**DEPARTMENT OF TRANSPORTATION**

Contract #: 04-0120F4Cty: SF/ALA Rte: 80 PM: 13.2/13.9File #: 69.25B**QUALITY ASSURANCE -- NON-CONFORMANCE REPORT****Location:** Changxing Island, Shanghai, P.R. China**Report No:** NCR-000651**Prime Contractor:** American Bridge/Fluor Enterprises, a JV**Date:** 24-Jan-2010**Submitting Contractor:** Zhenhua Port Machinery Company, Ltd (ZPMC), Changxing Island**NCR #:** ZPMC-0622**Type of problem:**

**Reference Description:** Missed MT Indication by QC for a weld joint on the Lift 12 Longitudinal Shear Plate**Description of Non-Conformance:**

**Subject:** NCR No. ZPMC-0622

<b>Welding</b>	<b>Concrete</b>	<b>Other</b>	
<b>Welding</b>	<b>Curing</b>	<b>Procedural</b>	<b>Bridge No:</b> 34-0006
<b>Joint fit-up</b>	<b>Coating</b>	<b>Other</b>	<b>Component:</b> Lift 12 Longitudinal Shear Plate
<b>Procedural</b>	<b>Procedural</b>	<b>Description:</b> Missed MT indication by QC

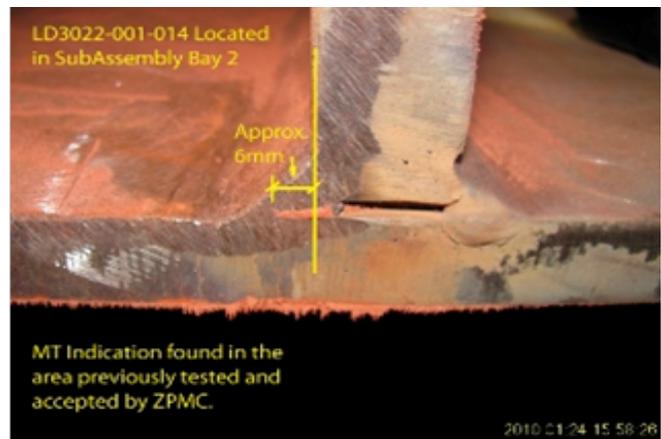
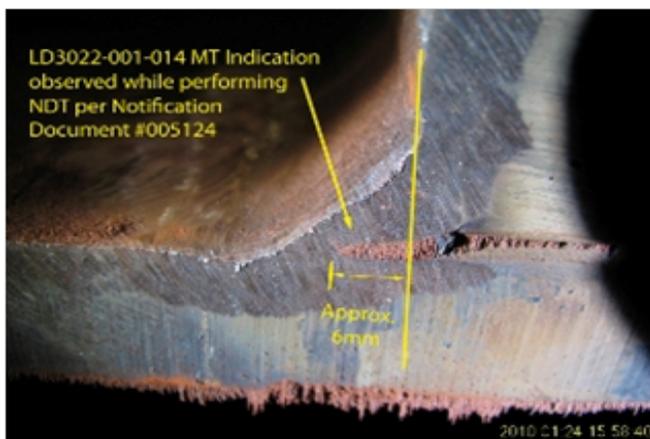
During the Quality Assurance Magnetic Particle Testing (MT) review of welds located on LD3022-001, this Quality Assurance Inspector (QA) discovered the following issues:

- One (1) linear indication measuring approximately 6mm in length.
- The weld is identified as: LD3022-001-014 for Lift 12.
- The area was previously repaired by ZPMC using Critical Weld Repair (CWR) 1151.
- The fillet weld size is 12mm.
- This Fillet Weld joins longitudinal diaphragm stiffener to longitudinal diaphragm web plate.
- This weld is designated as Non-Seismic Performance Critical Member.
- The Notice of Witness Inspection Number (NWIT) is 005124. The indication is located inside the area that has been previously tested and accepted by ZPMC Quality Control (QC) personnel. ZPMC Quality Control (QC) has performed 100% Magnetic particle Testing (MT) of this weld.

Propose a resolution for the identified recurring non-conformance which constitutes a systematic problem on both materials/workmanship and quality control issues with revised procedures to remedy the defected work and to prevent future occurrences. A response for the resolution of this issue is expected within 14 days.

项目名称 Project Name:	美国海湾大桥 SFOBB	部件图号 Drawing No.:	BK1	报告编号 Report No.:	B-CWR102
合同号 Contract No.:	04-0120F4	部件名称 Item Name:	DBG CANTILEVER BOX BRACKET	NDT 报告编号 NDT Report No.:	B787-MT-174
项目编号 Project No.:	ZP06-787

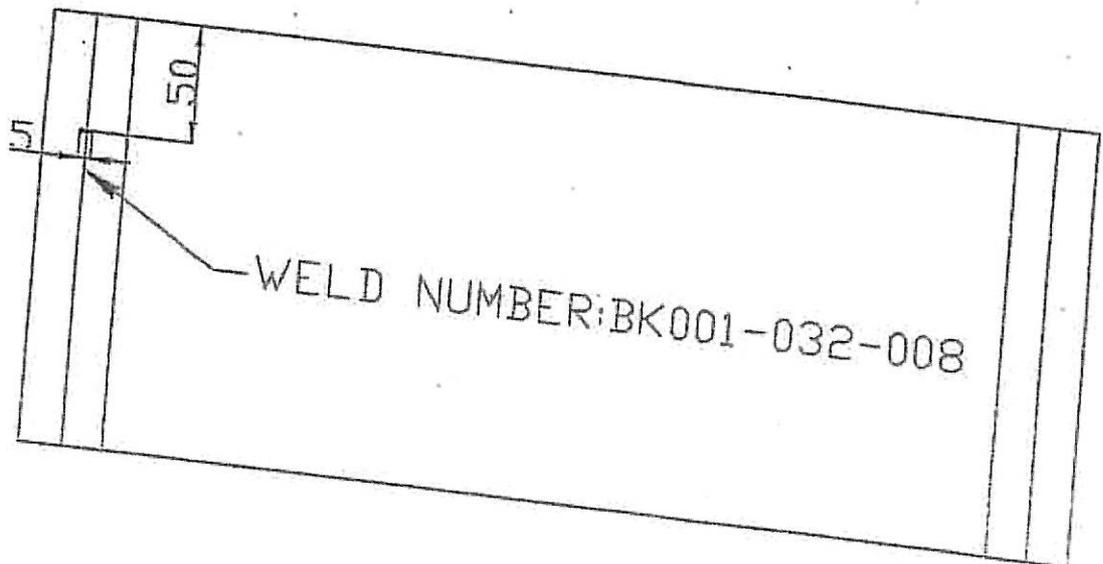
One transverse crack was found by use of MT on BK001-032-008.

2. QC and a Lead CWI shall have an approved copy of the CWR in hand prior to the repair.
3. Remove paint  $\geq 25$ mm in all direction of HAZ prior to MT.

6. Prepare excavation in accordance with the New Repair Procedure prior to welding.
7. Before this repair, Verify with VT and MT repair areas are defects free, and also MT shall be performed on the base metal laying abroad cracks to ensure that no cracks were propagated to the base metal. Separate CWR approval is needed if cracks are found in the base metal, and only after this new CWR's approval can continue the repair.

项目名称 Project Name	美国海湾大桥 SFOBB	部件图号 Drawing No	CB202A	报告编号 Report No.	B-WR10060
合同号 Contract No.	04-0120F4	部件名称 Items Name	CB16 STRUT	NDT报告编号 Report No. of NDT	B787-UT-10854
项目编号 Project No.:	ZP06-787

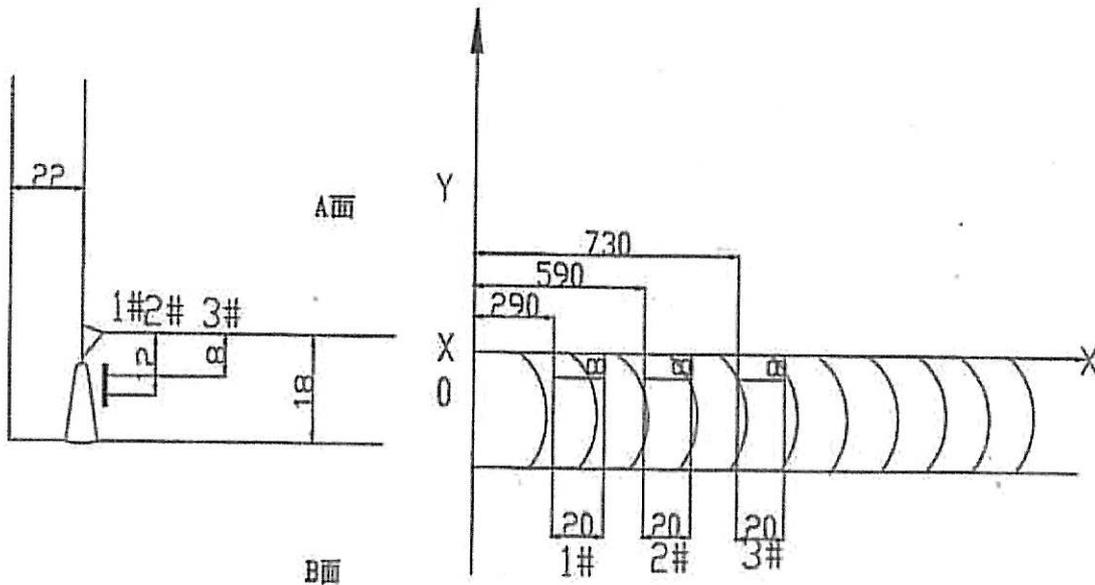
Rejected indication found by ultrasonic inspection is less than the maximum allowance aggregate length.

(UT探伤发现的缺陷总长度小于最大允许长度。) CB202A-016-002

1. 从缺陷距离端面较近一侧 ( $D \leq 0.65T$ , D为缺陷深度, T为板厚) 采用碳锉或打磨的方法去除焊缝缺陷;
  2. 参照返修焊接工艺规程 (WPS) 准备正确的接头型式, 预热和焊接;
  3. 焊前对修补区域进行VT检测保证缺陷完全被清除;
  4. 将修补区域打磨到与母材或邻近焊缝平齐;
  5. 根据批准的车间图纸检查焊缝.
- 
1. Gouge or grind from nearer side from metal edge ( $D \leq 0.65T$ , "D" is depth of defects, "T" is thickness of metal) to remove all defects;
  2. Follow repair WPS for joint preparation, preheat, and weld deposit;
  3. Verify with VT no defects remain in the weld joint prior to welding;
  4. Grind the repaired area flush with base metal or the adjacent weld;
  5. Check the welds according to the working drawings;

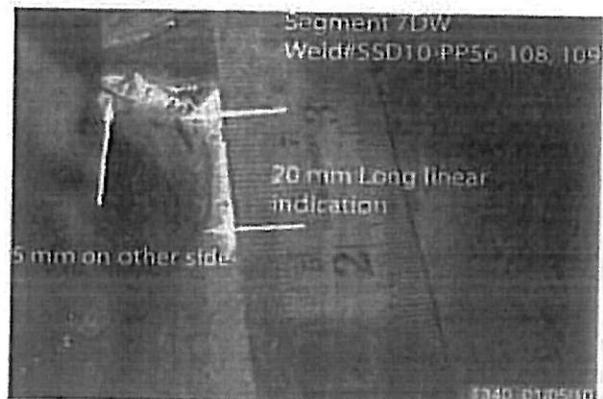
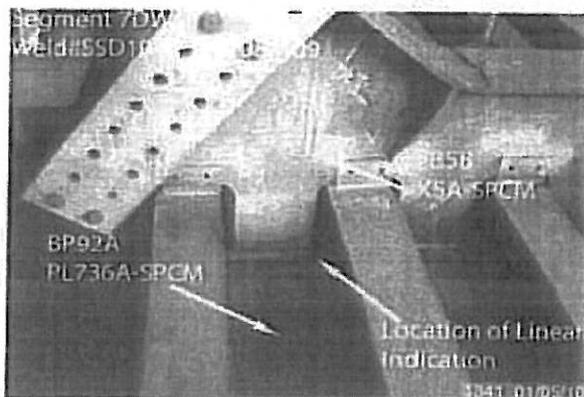
During the Quality Assurance Magnetic Particle Testing (MT) review of welds located on Segment 7DW, this Quality Assurance Inspector (QA) discovered the following issues:

- One (1) Longitudinal linear indication measuring approximately 20mm in length.

- The welds are identified as: SSD10-PP56-108, 109.

- These welds are a Fillet Weld type joining the Bottom Plate (BP92A) to Floor Beam (FB5B) web plate.

- These welds are designated as Seismic Performance Critical Member (SPCM) on the approved drawing (SEGSD10).

Propose a resolution for the identified non-conformance with revised procedures to prevent future occurrences. Provide the training and equipment required for the ZPMC MT technician such that these indications are found. A response for the resolution of this issue is expected within 7 days.

项目名称 Project Name:	美国海湾大桥 SFOBB	部件图号 Drawing No.:	SSD10	报告编号 Report No.:	B-CWR1043
合同号 Contract No.:	04-0120F4	部件名称 Item Name:	OBG FLOOR BEAM AND BOTTOM PLAT E	NDT 报告编号 NDT Report No.:	B787-MT-17605
项目编号 Project No.:	ZP06-787

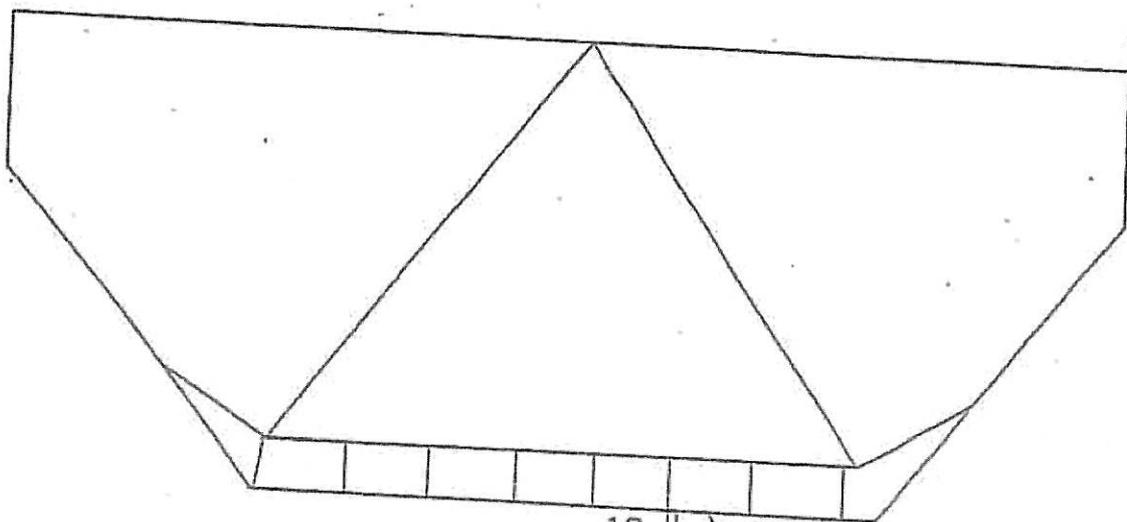
One longitudinal crack was found by use of MT on SSD10-PP56-108.

2. QC and a Lead CWI shall have an approved copy of the CWR in hand prior to the repair.
3. Remove paint ≥25mm in all direction of HAZ prior to MT.
4. Clean the excavation area of all loose debris including MT powder. Preheat to 65° C before removing cracks by grinding, repair area shall extend a minimum of 50mm beyond each end of single crack repairs.

6. Prepare excavation in accordance with the New Repair Procedure prior to welding.
7. Before this repair, Verify with VT and MT repair areas are defects free, and also MT shall be performed on the base metal laying abroad cracks to ensure that no cracks were propagated to the base metal. Separate CWR approval is needed if cracks are found in the base metal, and only after this new CWR's approval can continue the repair.

项目名称 Project Name:	美国海湾大桥 SFOBB	部件图号 Drawing No.:	SSD11	报告编号 Report No.:	B-CWR1044
合同号 Contract No.:	04-0120F4	部件名称 Item Name:	OBG FLOOR BEAM AND BOTTOM PLAT E 7DW	NDT 报告编号 NDT Report No.:	B787-MT-1760
项目编号 Project No.:	ZP06-7B7

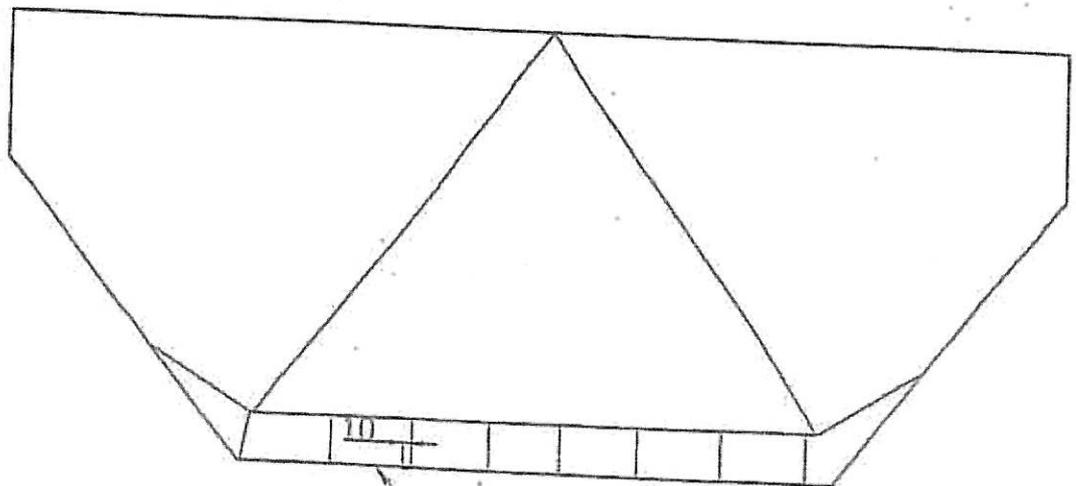
One longitudinal crack was found by use of MT on SSD11-PP57-0B4.

2. QC and a Lead CWI shall have an approved copy of the CWR in hand prior to the repair.
3. Remove paint  $\geq 25$ mm in all direction of HAZ prior to MT.

6. Prepare excavation in accordance with the New Repair Procedure prior to welding.
7. Before this repair, Verify with VT and MT repair areas are defects free, and also MT shall be performed on the base metal laying abroad cracks to ensure that no cracks were propagated to the base metal. Separate CWR approval is needed if cracks are found in the base metal, and only after this new CWR's approval can continue the repair.

项目名称 Project Name:	美国梅湾大桥 SFOBB	部件图号 Drawing No.:	SSD11	报告编号 Report No.:	B-CWR1
合同号 Contract No.:	04-0120F4	部件名称 Item Name:	BCW FLOOR BEAM SPLICE	NDT 报告编号 NDT Report No.:	B787-MT-1
项目编号 Project No.:	ZP06-787

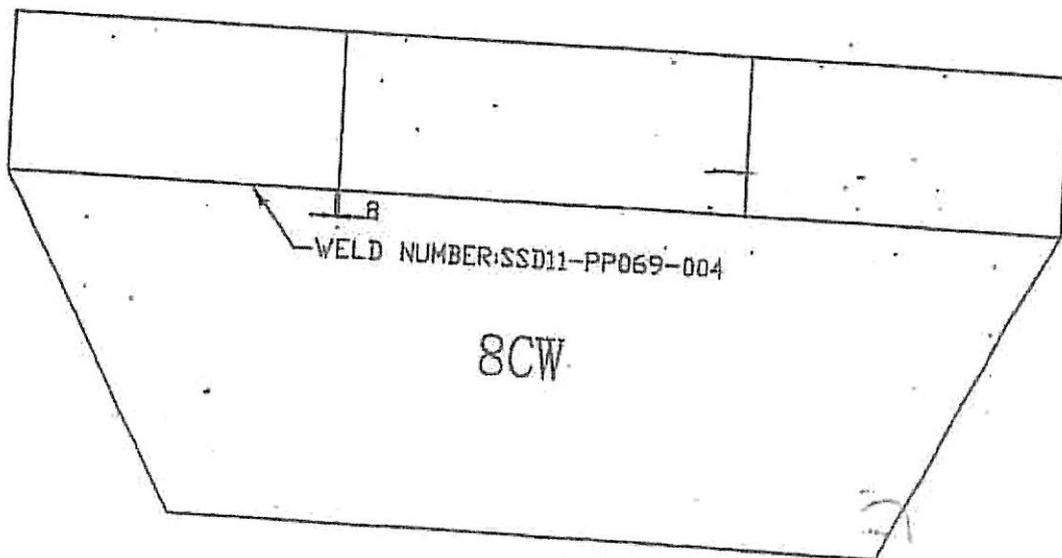
One longitudinal crack was found by use of MT on SSD11-PP69-004.

2. QC and a Lead CWI shall have an approved copy of the CWR in hand prior to the repair.
3. Remove paint  $\geq 25$ mm in all direction of HAZ prior to MT.

6. Prepare excavation in accordance with the New Repair Procedure prior to welding.
7. Before this repair, Verify with VT and MT repair areas are defects free, and also MT shall be performed on the base metal laying abroad cracks to ensure that no cracks were propagated to the base metal. Separate CWR approval is needed if cracks are found in the base metal, and only after this new CWR's approval can continue the repair.

Joint fit-up  Coating  Other  Component: 7DW Floor Beam to Deck Panel Diaphragm

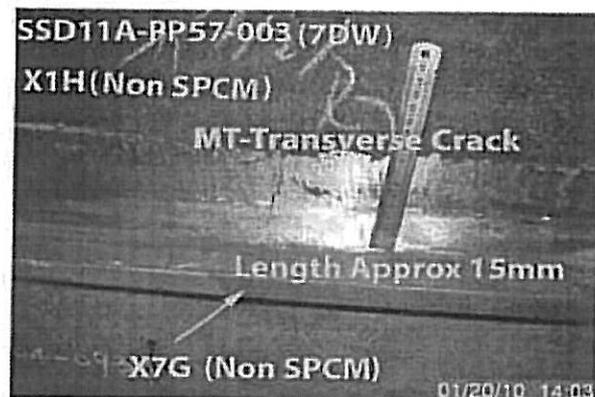
Procedural  Procedural  Description: Missed MT transverse indication by QC

Reference Description: MT Transverse Crack discovered after ZPMC tested and accepted this weld (7DW floorbeam to deck panel diaphragm joint)

Propose a resolution for the identified recurring non-conformance which constitutes a systematic problem on both materials/workmanship and quality control issues with revised procedures to remedy the defected work and to prevent future occurrences. A response for the resolution of this issue is expected within 14 days.

项目名称 Project Name:	美国海湾大桥 SFOBB	部件图号 Drawing No.:	SEG039	报告编号 Report No.:	B-CWR1167
合同号 Contract No.:	04-0120F4	部件名称 Item Name:	DBG DECK PLATE SPlice 7BW	NDT 报告编号 NDT Report No.:	B787-MT-18475
项目编号 Project No.:	ZP06-787

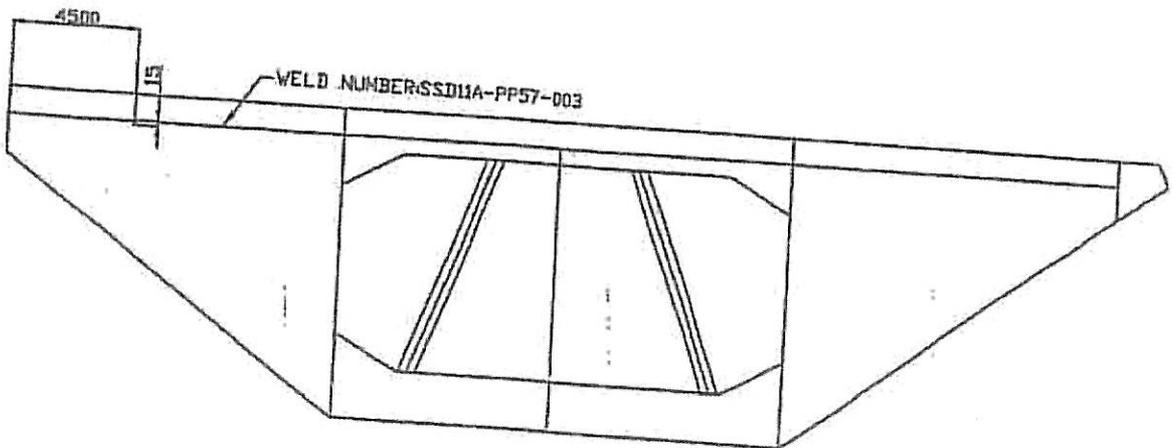
One transverse crack was found by use of MT on SSD11A-PP57-003.

14. 返修后根据图纸进行VT, UT和MT检测, 并按照合同10-1.59 "钢结构" 中的 "检测和试验" 要求进行附加MT检测.
1. QC and a Lead CWI shall be present, direct and supervise all grinding and welding operations during this repair to ensure the repair is per the disposition requirements.

2. QC and a Lead CWI shall have an approved copy of the CWR in hand prior to the repair.
  3. Remove paint ≥25mm in all direction of HAZ prior to MT.
  4. Clean the excavation area of all loose debris including MT powder. Preheat to 65° C before removing cracks by grinding and it applied to all the repair process. Repair area shall extend a minimum of 50mm beyond each end of single crack repairs,

7. Before this repair, Verify with VT and MT repair areas are defects free, and also MT shall be performed on the base metal laying around cracks to ensure that no cracks were propagated to the base metal. Separate CWI approval is needed if cracks are found in the base metal, and only after this new CWR's approval can continue the repair.

Location: Changxing Island, Shanghai, P.R. China Report No: NCR-000651  
Prime Contractor: American Bridge/Fluor Enterprises, a JV Date: 24-Jan-2010  
Submitting Contractor: Zhenhua Port Machinery Company, Ltd (ZPMC), Changxing Island NCR #: ZPMC-0622

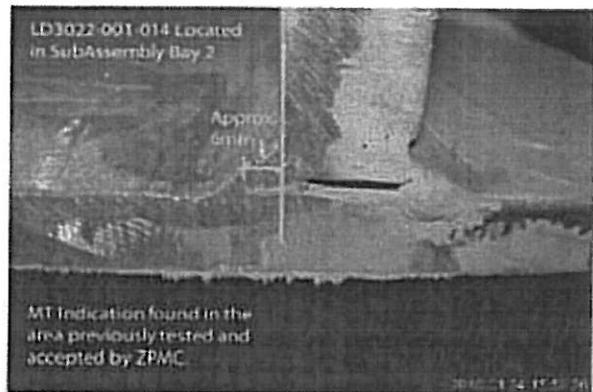
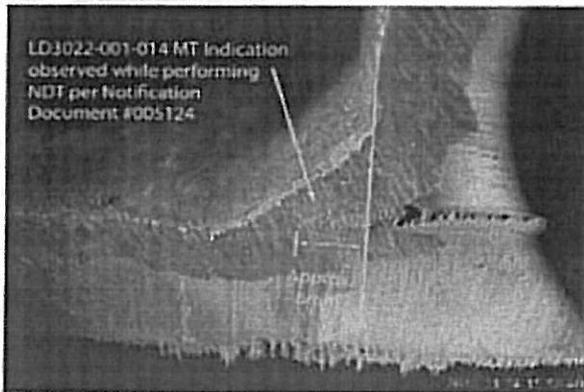
- Welding  Concrete  Other
- Welding  Curing  Procedural  Bridge No: 34-0006
- Joint fit-up  Coating  Other  Component: Lift 12 Longitudinal Shear Plate
- Procedural  Procedural  Description: Missed MT indication by QC

Reference Description: Missed MT Indication by QC for a weld joint on the Lift 12 Longitudinal Shear Plate

Propose a resolution for the identified recurring non-conformance which constitutes a systematic problem on both materials/workmanship and quality control issues with revised procedures to remedy the defected work and to prevent future occurrences. A response for the resolution of this issue is expected within 14 days.

项目名称 Project Name:	美国海湾大桥 SFOBB	部件图号 Drawing No.:	LD3022	报告编号 Report No.:	B-CWR1151
合同号 Contract No.:	04-0120F4	部件名称 Item Name:	12 <sup>th</sup> lifting longitudinal diaphragm	NDT 报告编号 NDT Report No.:	B787-MT-17930
项目编号 Project No.:	ZP06-787

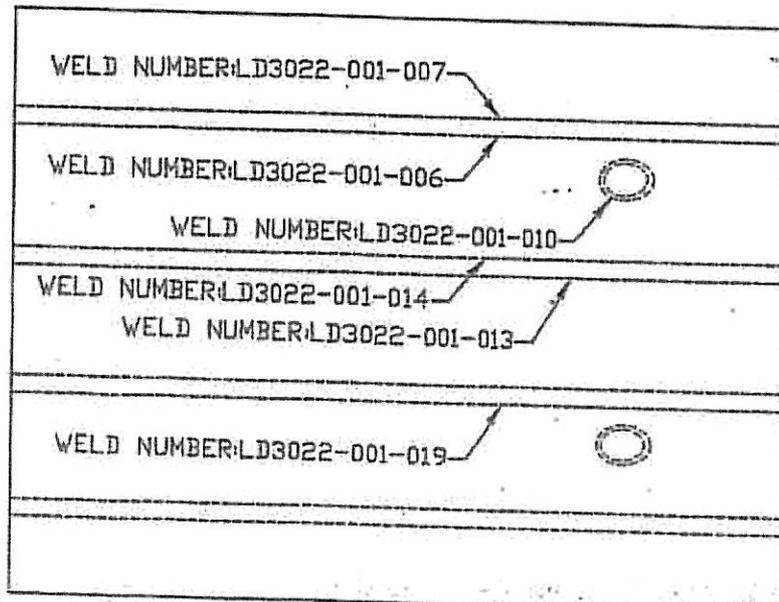
- One pore and two transverse cracks were found by use of MT on LD3022-001-006.
- One longitudinal crack and four transverse cracks were found by use of MT on LD3022-001-007.
- One pore and one transverse crack were found by use of MT on LD3022-001-010.
- One pore and two transverse cracks were found by use of MT on LD3022-001-013.
- One longitudinal crack and one transverse crack were found by use of MT on LD3022-001-014.
- One pore and one transverse crack were found by use of MT on LD3022-001-019.

2. QC and a Lead CWI shall have an approved copy of the CWR in hand prior to the repair.
3. Remove paint  $\geq 25$ mm in all direction of HAZ prior to MT.

6. Prepare excavation in accordance with the New Repair Procedure prior to welding.
7. Before this repair, Verify with VT and MT repair areas are defect free, and also MT shall be performed on the base metal laying abroad cracks to ensure that no cracks were propagated to the base metal. Separate CWR approval is needed if cracks are found in the base metal, and only after this new CWR's approval can continue the repair.

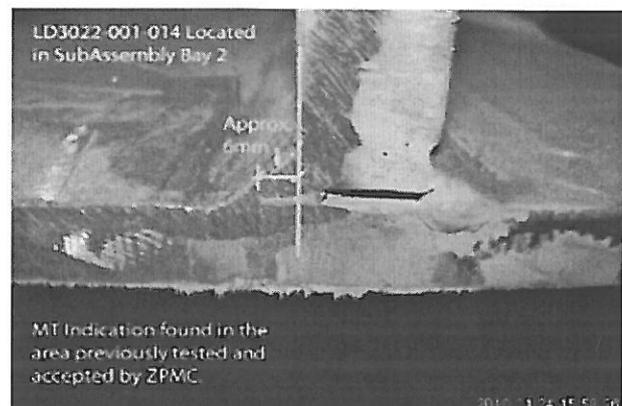
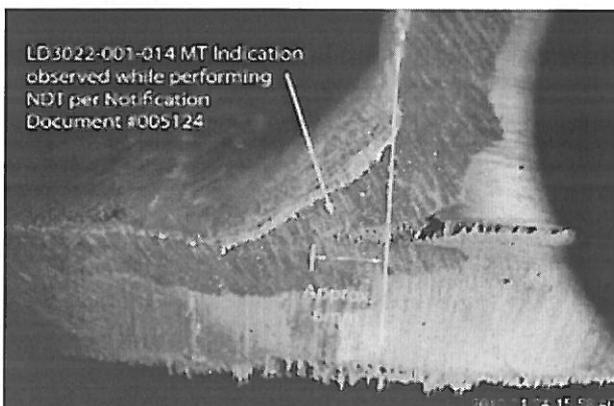
-One (1) linear indication measuring approximately 6mm in length.

-The weld is identified as: LD3022-001-014 for Lift 12.

-The area was previously repaired by ZPMC using Critical Weld Repair (CWR) 1151.

-The fillet weld size is 12mm.

Repair said indication and perform NDT required to verify weld quality.

项目名称 Project Name:	美国海湾大桥 SFOBB	部件图号 Drawing No.:	LD3022	报告编号 Report No.:	B-CWR1151
合同号 Contract No.:	04-0120F4	部件名称 Item Name:	12 <sup>th</sup> lifting longitudinal diaphragm	NDT 报告编号 NDT Report No.:	B787-MT-17930
项目编号 Project No.:	ZP06-787

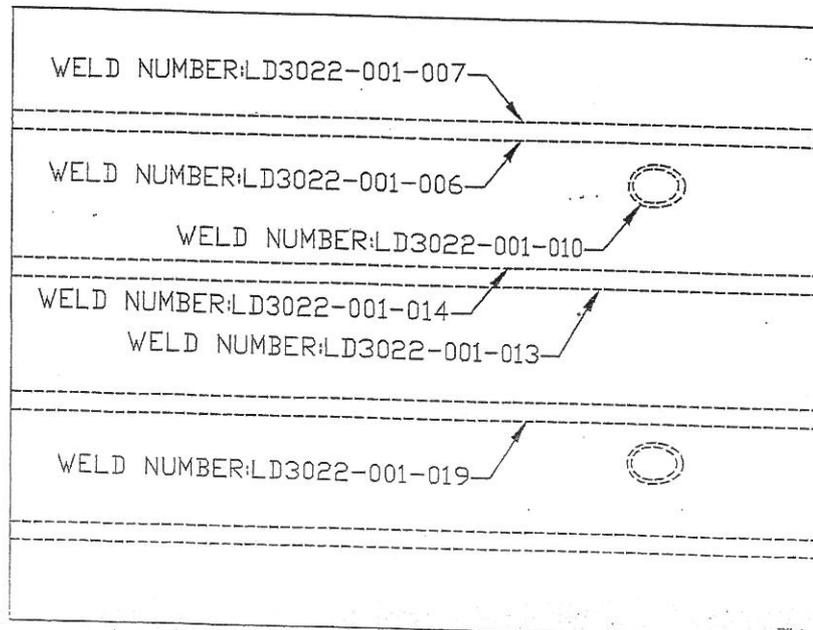
One longitudinal crack and one transverse crack were found by use of MT on LD3022-001-014.

One pore and one transverse crack were found by use of MT on LD3022-001-019.

2. QC and a Lead CWI shall have an approved copy of the CWR in hand prior to the repair.
3. Remove paint  $\geq 25$ mm in all direction of HAZ prior to MT.

6. Prepare excavation in accordance with the New Repair Procedure prior to welding.
7. Before this repair, Verify with VT and MT repair areas are defects free, and also MT shall be performed on the base metal laying abroad cracks to ensure that no cracks were propagated to the base metal. Separate CWR approval is needed if cracks are found in the base metal, and only after this new CWR's approval can continue the repair.
